**TOWN OF NEWBURGH
PLANNING BOARD**

TECHNICAL REVIEW COMMENTS

PROJECT NAME: PRESTIGE HOMES LOT LINE CHANGE
PROJECT NO.: 24-30
PROJECT LOCATION: SECTION 53, BLOCK 2, LOT 10 & 11
REVIEW DATE: 8 JANUARY 2025
MEETING DATE: 16 JANUARY 2025
PROJECT REPRESENTATIVE: ZEN CONSULTANTS, INC.

STAKED STRAW BALE PLAN
N.T.S.

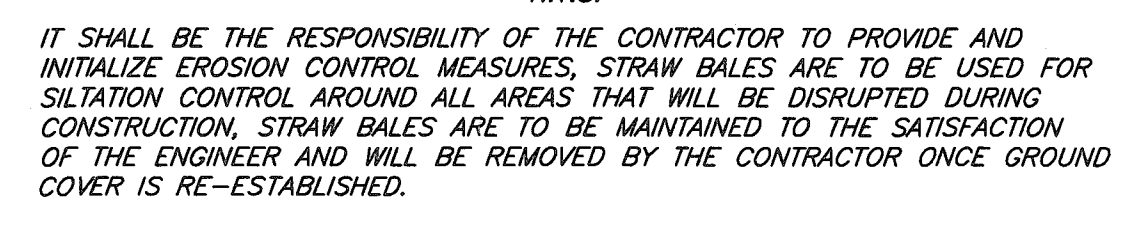
6. Erosion and sediment notes referencing hay bales, as well as hay bale details should be removed. Silt fence should be utilized hay bales are not an acceptable practice.

SITE PLAN
1"=20'

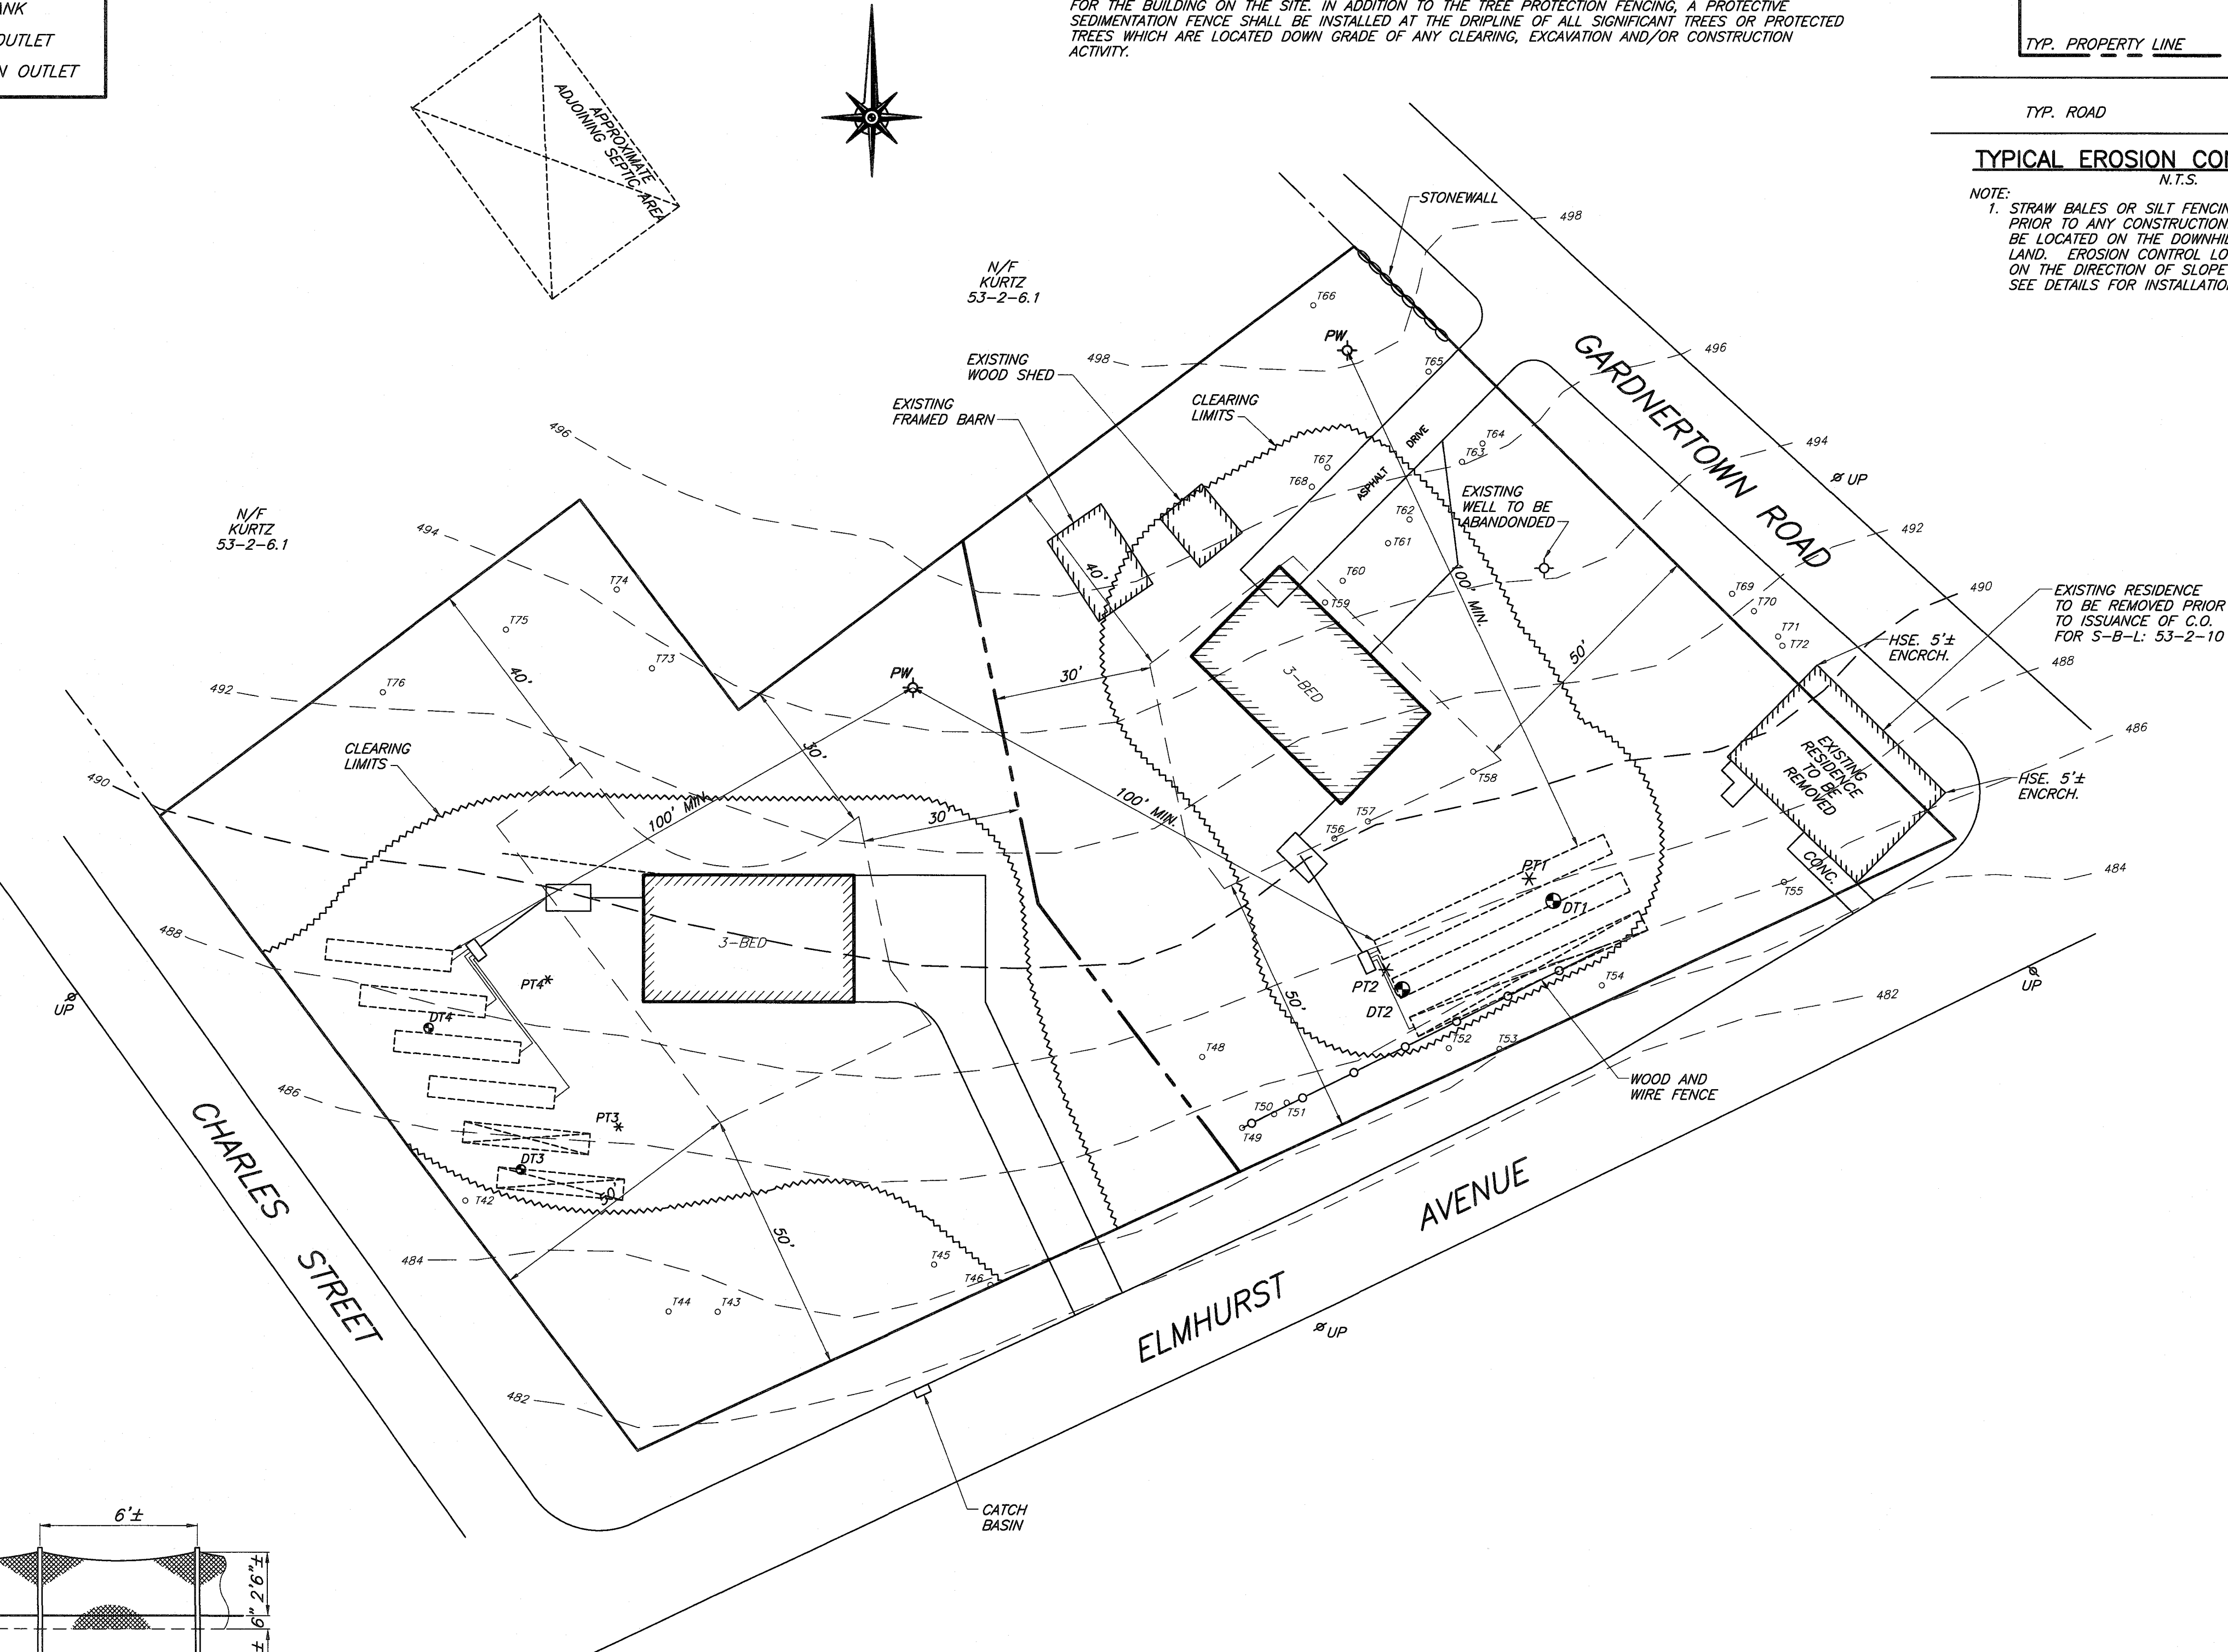
4. Dimension of separation distance proposed septic laterals on Tax Lot 11 show the required 10 - foot separation distance from the property line.
5. The trees have been located on the plans. Compliance with the Tree Preservation Ordinance has been documented.
